UNITED STATES PATENT AND TRADEMARK OFFICE

APPLICATION NO.	FILING DATE	FIRST NAMED INVENTOR	ATTORNEY DOCKET NO.	CONFIRMATION NO.
09/802,449	03/09/2001	Peter W. Johnson	PJ0101US	7014

Office Action Summary

DETAILED ACTION

Prior Art: Figure 3 of US Patent 6,323,843 to Giles

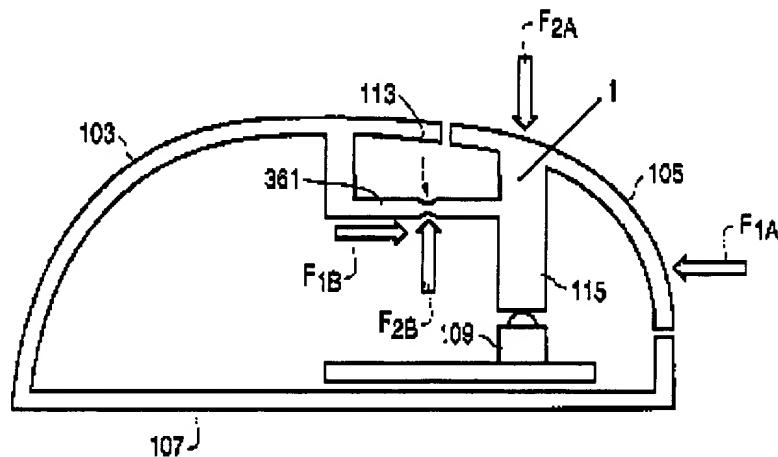
Claims 1-4 rejected under 35 U.S.C. 102(e) as being anticipated by U.S. patent number 6,323,843 to Giles. Giles describes a button assembly that is very similar to the claimed invention. Giles discloses in figure 3 a button assembly comprising a first cantilever beam (361) having a first end and second end, the first end being configured to be attached to an electronic

input device through a first fulcrum (113) at the first end; a second cantilevered beam (105) having an exposed button portion (105), the second cantilevered beam being attached to the first cantilevered beam through a second fulcrum (1). As seen from the figure, the second fulcrum attaches the second cantilevered beam to the first cantilevered beam at the second end of the first cantilevered beam. A plunger (115) attached to the second cantilevered beam and extends from the second cantilevered beam through the first cantilevered beam (361). In column 5, line 7-9, Giles discloses that the button can be constructed from a single piece of molded plastic.

In reference to claim 5, Giles describes a computer pointing input device (Column 1, line 9) in his invention. Referring to figure 3, it is clear that Giles, discloses computer input device comprising a housing (103 and 105) a palm portion of the housing configured to receive a user's hand (103) with a distal portion of the housing extending generally away from the palm portion; a switch button (105) having a palm end (area affected by force F_{1A}) and a distal end (area affected by force F_{2A}) the switch button being configured to actuate an electronic switch (109) within the computer pointing input device upon application of sufficient force to the switch button by the user (F_{1A} , F_{2A} and column 3, lines 23-25), the switch button being movably coupled to the housing so as to move about a fulcrum (1). Giles describes an invention that resembles the claimed invention, however Giles never explicitly stated that the positioning of the fulcrum needed to be nearer to the distal end than the palm end of the switch button. The exact positioning of this fulcrum is a design variable that is not essential to the workings of the invention. There is no disclosed criticality as to require the fulcrum to be positioned in the claimed locality. The position of the fulcrum is a design variable that can be adjusted accordingly by one skilled in the art for the usability of the device.

Claim 9 is dependent on claim 5, and is rejected on the terms similar to the discussion outlined above. In addition, Giles describes a spring beam (361) having a first end and a second end, where the spring beam is coupled to the switch button (105) through the fulcrum (1) at the first end and coupled to the housing at the second end through a second fulcrum (113).

In reference to claim 6 and 10, Giles does describe, a first force applied to the switch button to actuate the electronic switch at the distal end (F_{1A}) and a second force is required to be

Claims 15, 16, 19 and 20 are rejected on the same merits discussed in the rejections of claims 5 and 9 with further understanding that Giles also discloses a plunger (115) coupled to the switch button and extends towards an electronic switch (109), with the plunger configured to actuate the electronic switch upon application of sufficient force to the switch button by the user

(column 3, lines 23-25). Also by referring to figure 3, the plunger extends through the spring beam (361). Finally, as disclosed in Giles (column 1, lines 8-9) his invention is a computer mouse.
